City of Surrey
PLANNING & DEVELOPMENT REPORT

File: 7912-0147-00

Planning Report Date: March 10, 2014

in order to permit the development of 4 commercial buildings.

DATE	SEPT 12, 2013
PROJECT NO.	GA-GG
SHEET TITLE	OVERALL SITE PLAN
REVISION NO.	SHEET NO.
	A1.0

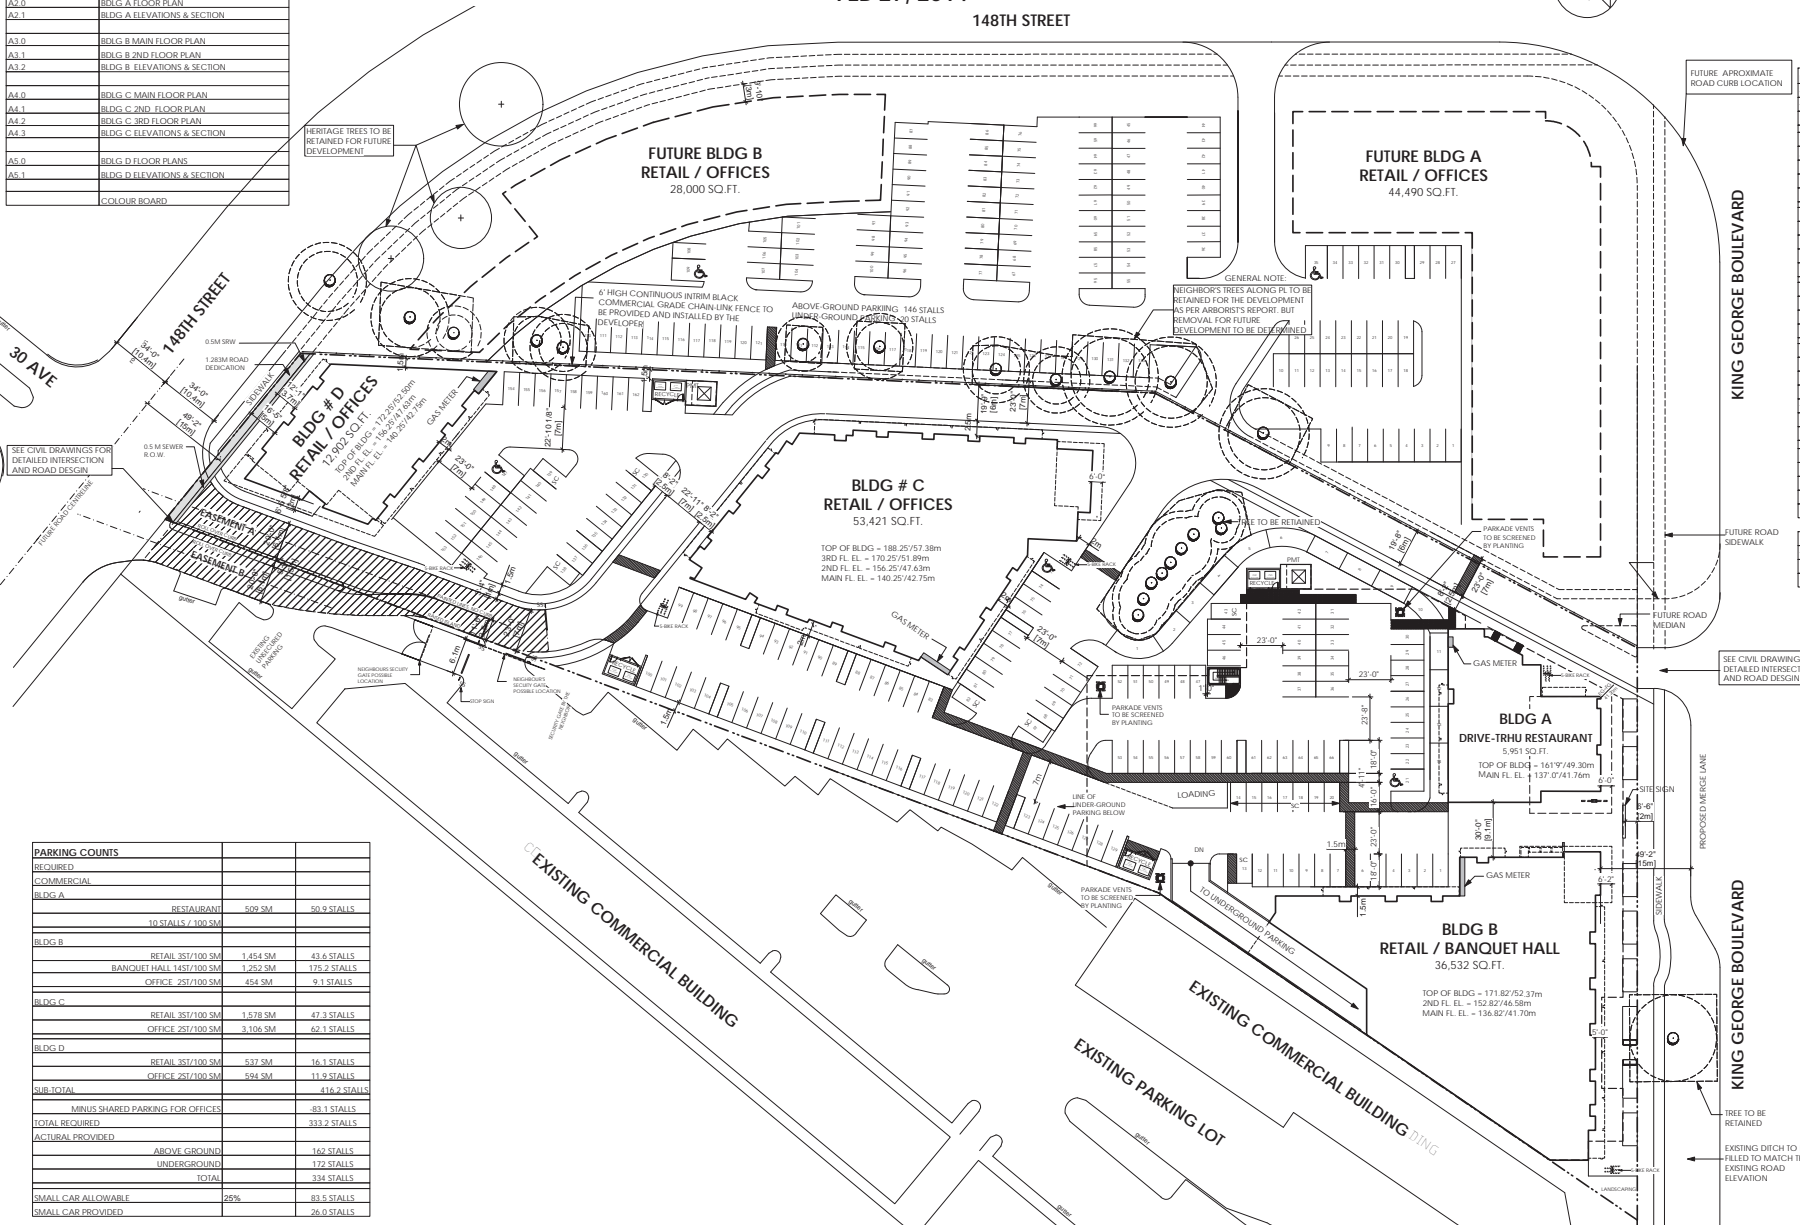
- The site, especially parking areas, could be more efficiently organized—create better open/green space opportunity.
- Important to provide an assigned loading space for restaurants and banquet hall.
- Definitely an improvement for the area.
- Generally good circulation but awkward around Building A and B - the main plaza should align with the pedestrian pathways.
- Underground parking is very good, could make larger to give more green space on surface.
- Good to have bioswales (ensure the bioswales can be accommodated), but there is a lot of impervious paving. Consider increasing the amount of permeable paving. Could be used more to organize the landscape areas, including consideration of developing more of a green route to enhance the experience.
- It would be helpful to have the street information on the plans such as sidewalks, boulevards, trees etc.

- *Important to provide an assigned loading space for restaurants and banquet hall.*
 - Provided an assigned loading space for restaurants and banquet halls.

- *Buildings are a bit tight, need more space.*
 - Made the space around each building loosen-up a bit to provide more green and pedestrian space.
- *Building elevations are very reserved and could be more interesting and invite people from King George Blvd. into the site, perhaps look more like the precedent images.*

DRAWING TITLE:
LANDSCAPE SHRUB PLAN WEST

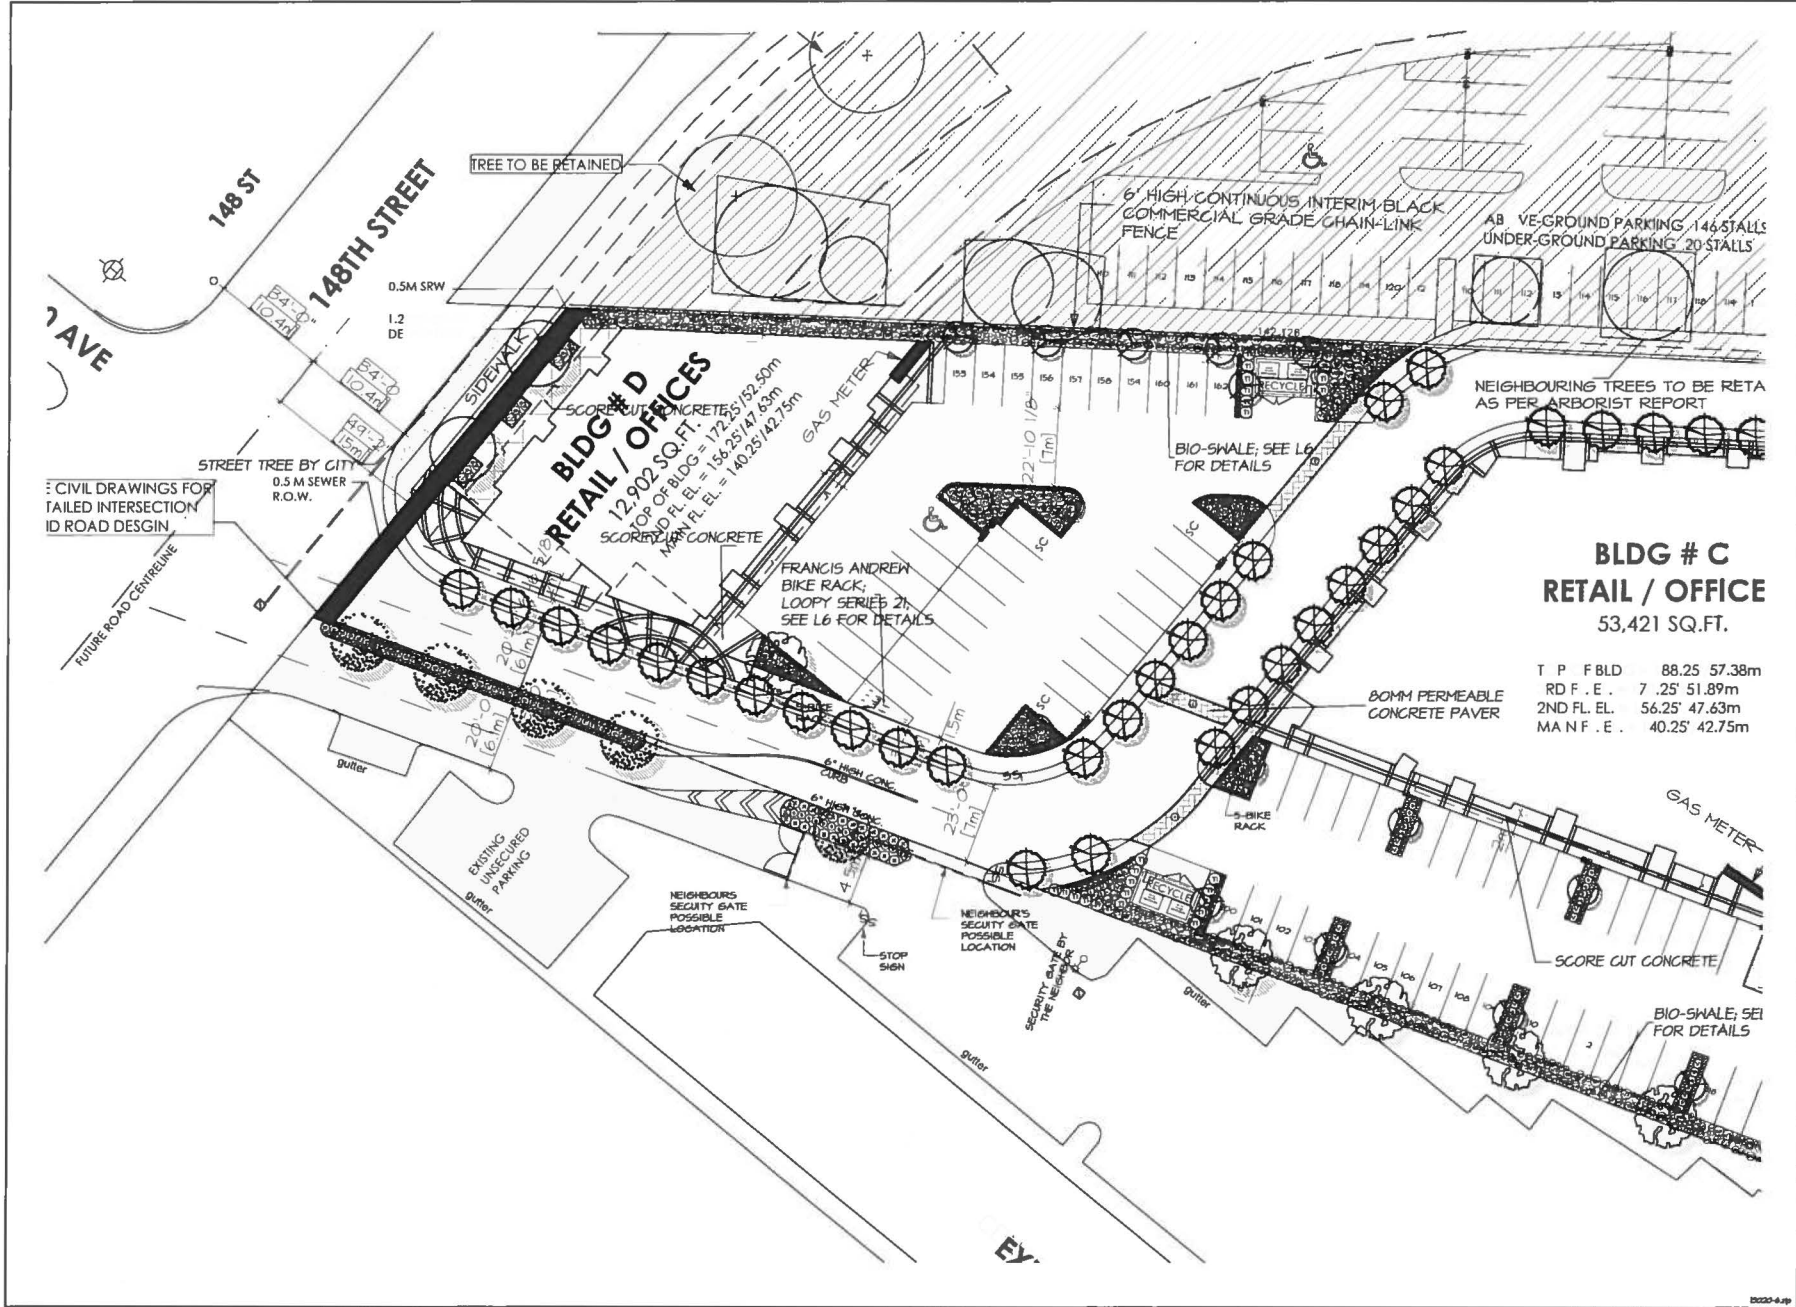
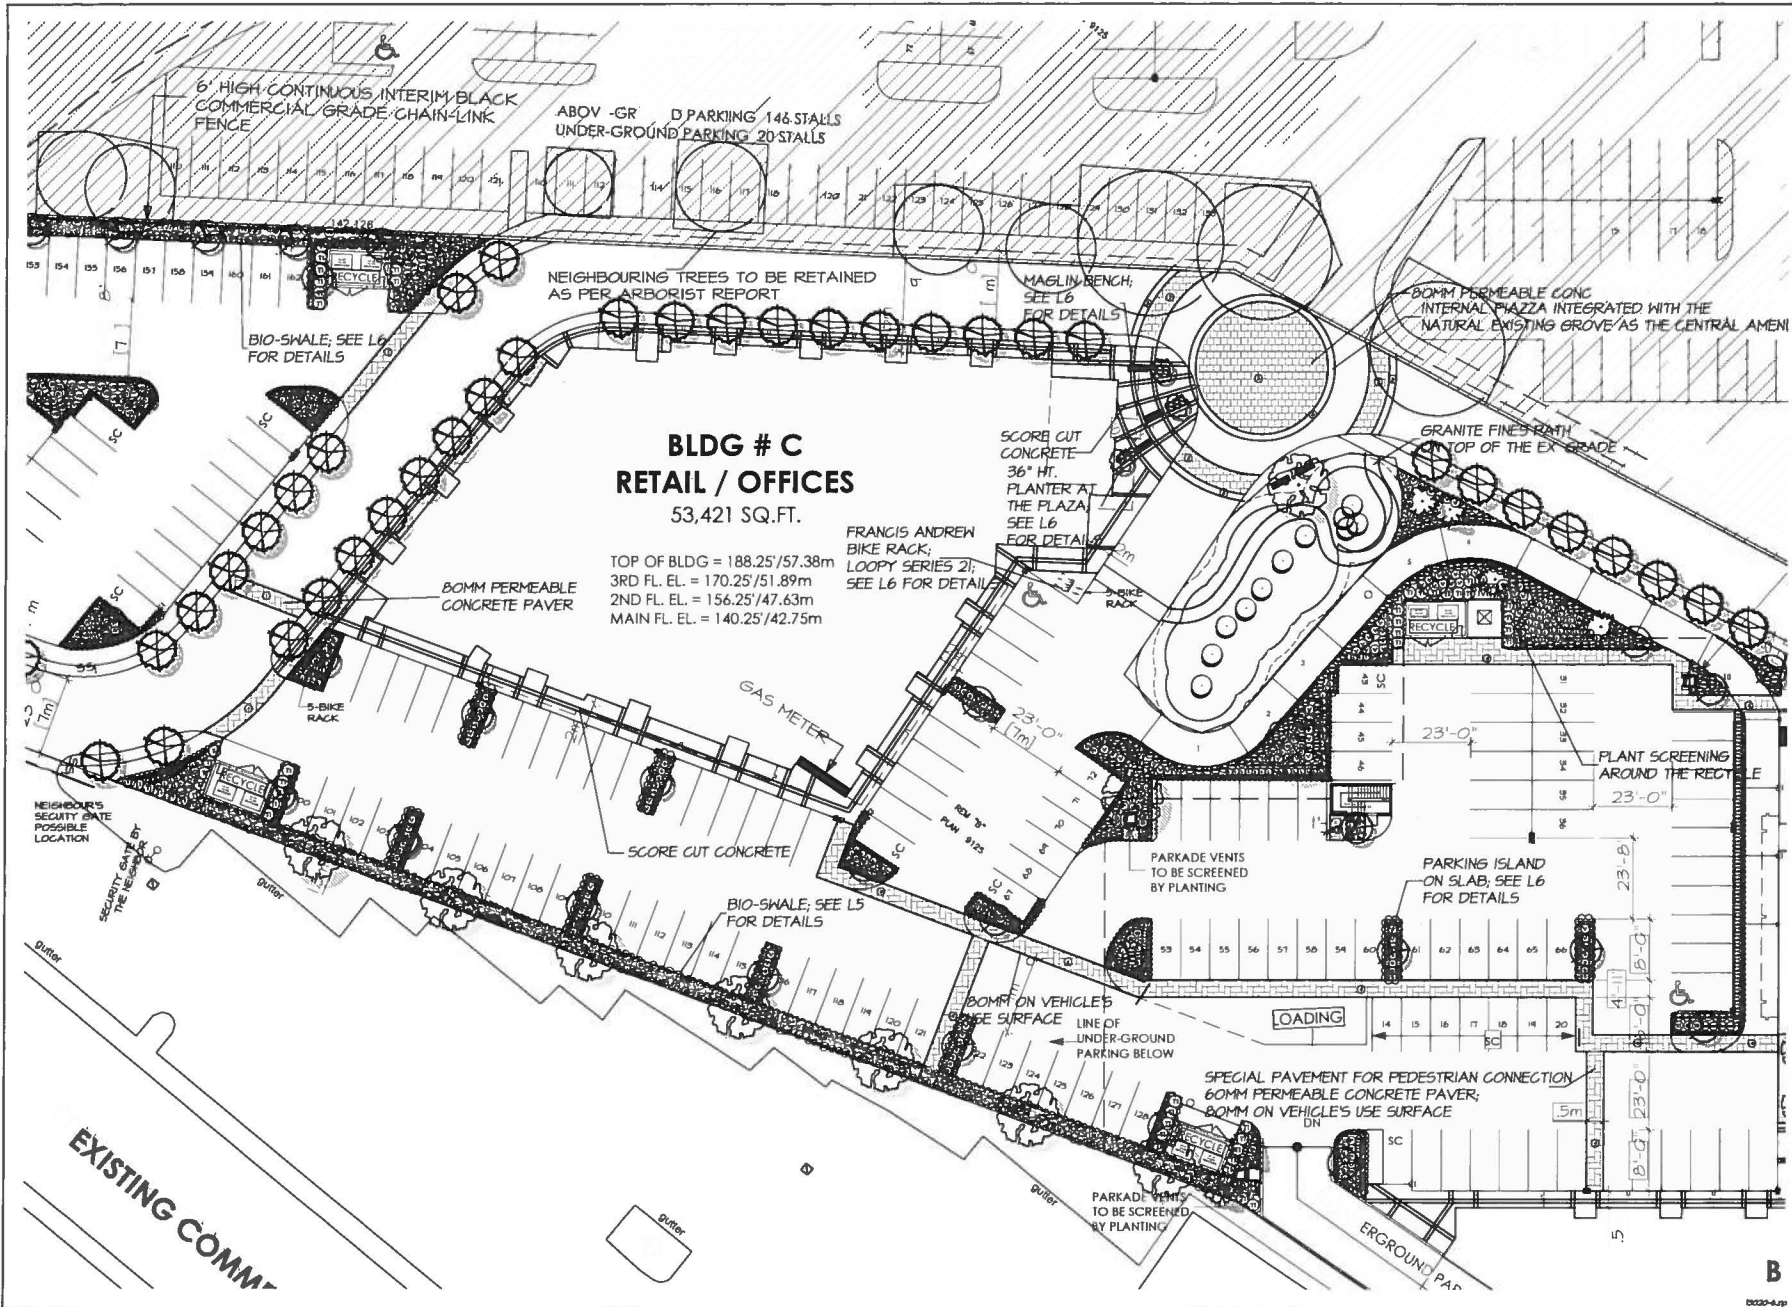
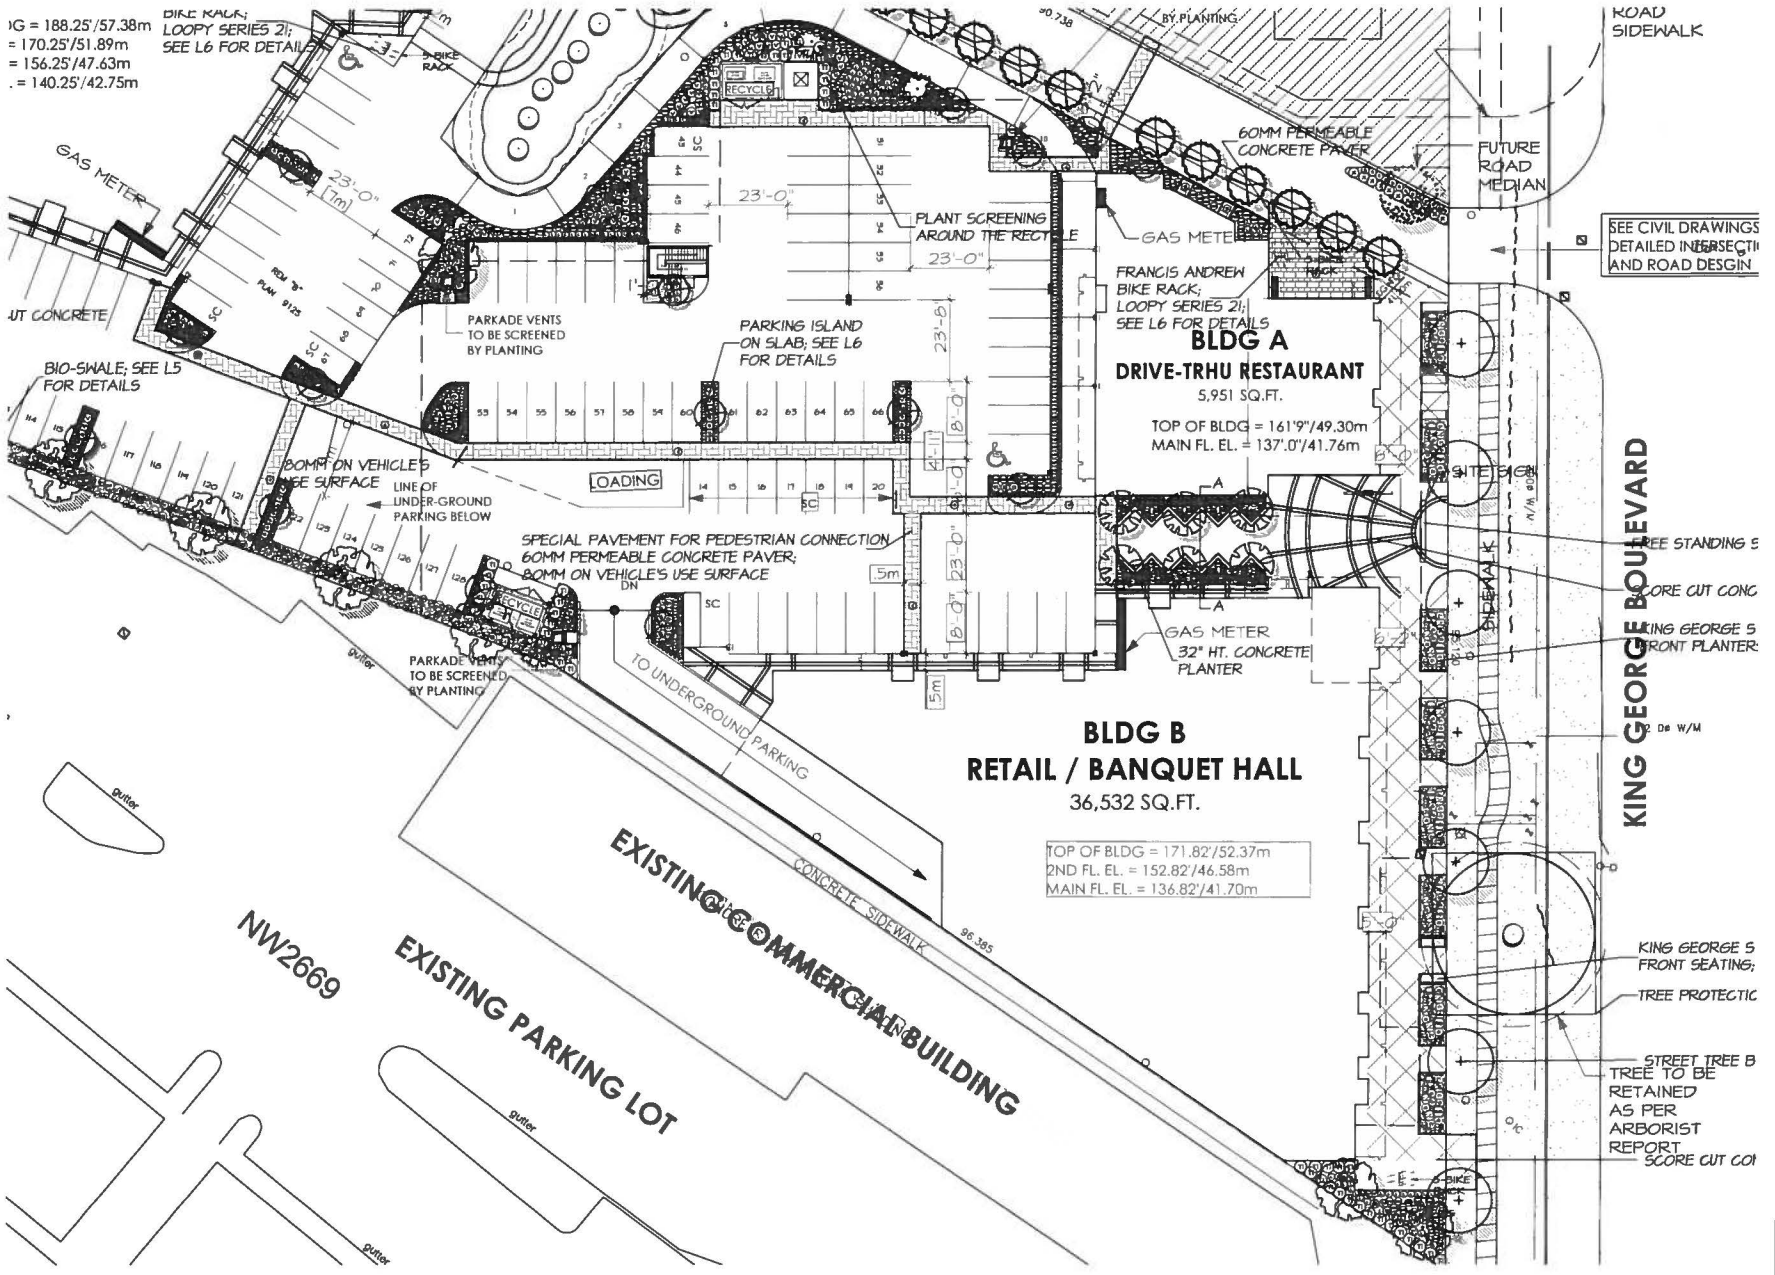
- The landscape drawings show the north site designed in detail, confusing, not part of this application.
- Provide landscape in front of Building D along 148 Street and at entrance driveway.

- The landscape drawings show the north site designed in detail, confusing, not part of this application.
The north site has been hatched and the notation "NIC" has been added.
- Provide landscape in front of Building D along 148 Street and at entrance driveway.
Off-site landscape and three planters on-site have been added in front of Building D. The landscaped traffic islands have been added at the driving entrance.
- Generally there needs to be more green in parking area with fully developed spaces as plazas rather than leftover spaces, more parking could be put underground to make room on surface.
More islands have been added in the parking area.

- main drive aisle has been revised with 1 meter boulevards on both sides. Columnar trees and lawn have been proposed on them to enhance the main driving corridor.
- Bio-swales have been relocated along east and west property lines.
- plazas were adjusted per function and form of the buildings.
- Pavement area is adjusted per the pedestrian system.
